**Addendum w to
ASHRAE Guideline 36-2018**

Proposed Addendum w to Guideline 36-2018, High-Performance Sequences of Operation for HVAC Systems

**First Public Review (November 2020)
(Draft shows Proposed Changes to Current Guideline)**

Figure 5.2.1.4-3 $Vmin^*$ reset with CO_2 loop (SZVAV).

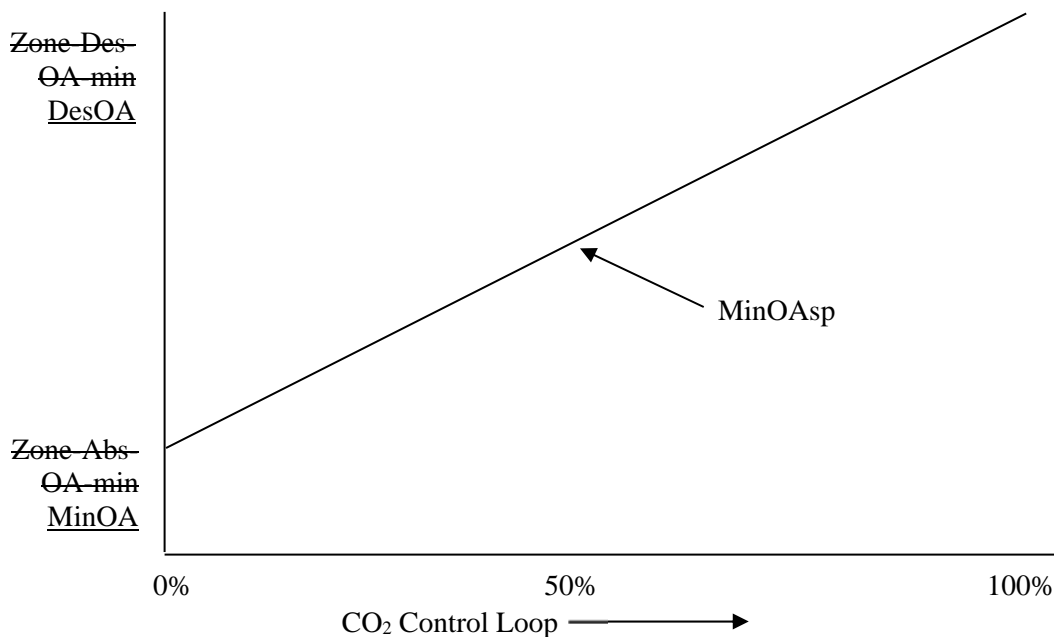
Revise Paragraph 5.2.1.4.d.3.vi as follows:

- (a) The minimum outdoor air set point $MinOAsp$ shall be reset based on the zone CO_2 control-loop signal from ~~Zone Abs OA min~~ $MinOA$ at 0% signal to ~~Zone Des OA~~ $DesOA$ at 100% signal. See Figure 5.2.1.4-3.
